CHANGED BY	DATE/CORR.	CONTR./APPR.	DESIGNED	SUBJECT	DRAWING NO.	OLD DRAWING NO.	EDITION
---	920210/KWK	JK MT	---	FILTERDIAGRAM	090689	2610 + 261023	C
---	920928/LS	JK MT	---	CONSEQUENCE	---	---	---
---	981210/HTA	---	---	---	---	---	---
---	991201/LM	---	---	---	---	---	---

FILTERDIAGRAM
CONSEQUENCE

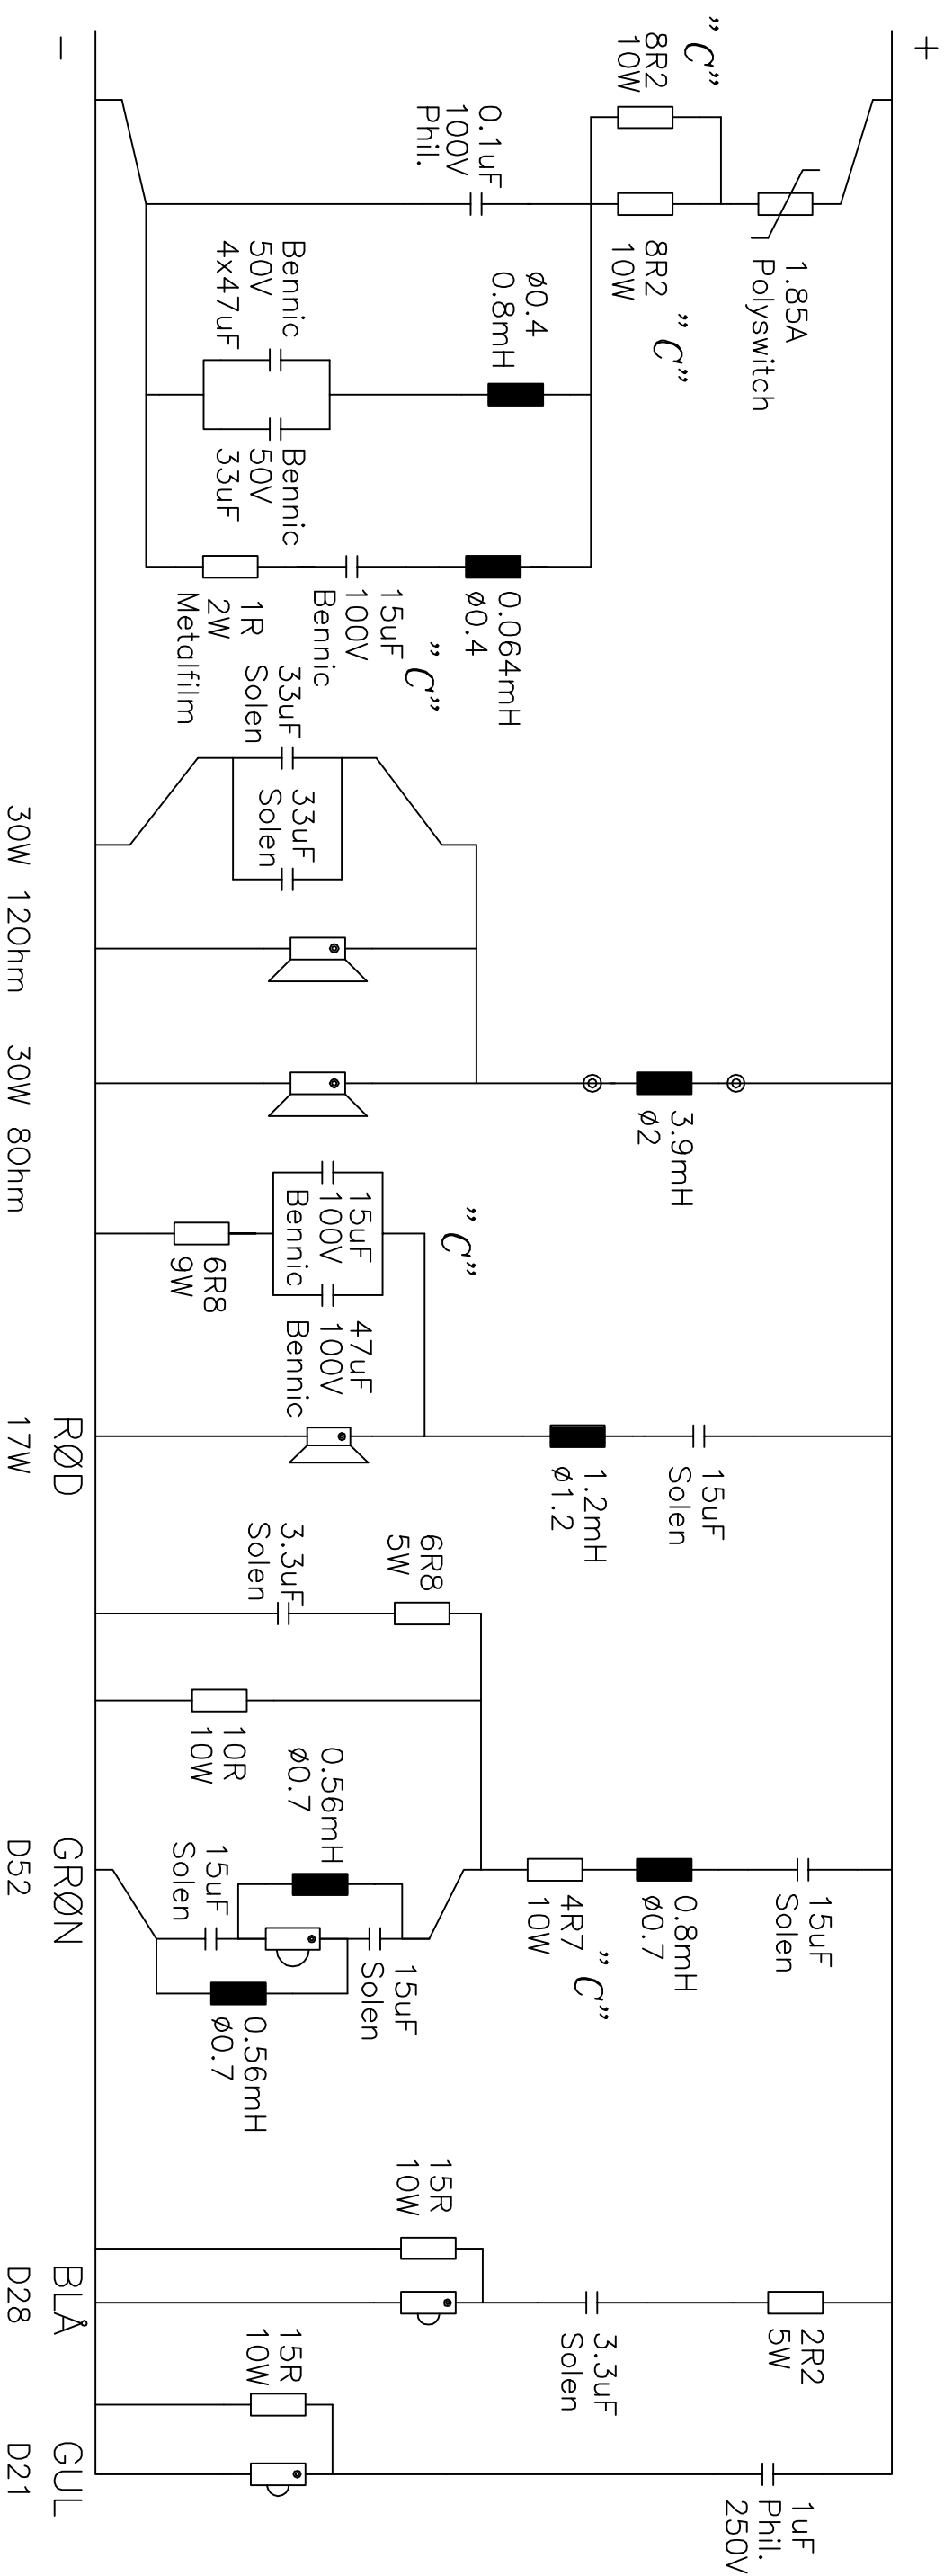
EDITION	DESCRIPTION	REV.
"B"	POLYSWITCH 1.85A PASAT, MED VIRKING FRA SERIE NR. 979	---
"C"	WICON KONDENSATOR UDSKIFTEJ MED BENNIC + MODSTAND 9W ANDR. TIL 10W 4R7/548 + TEJNING OPDATERET.	---
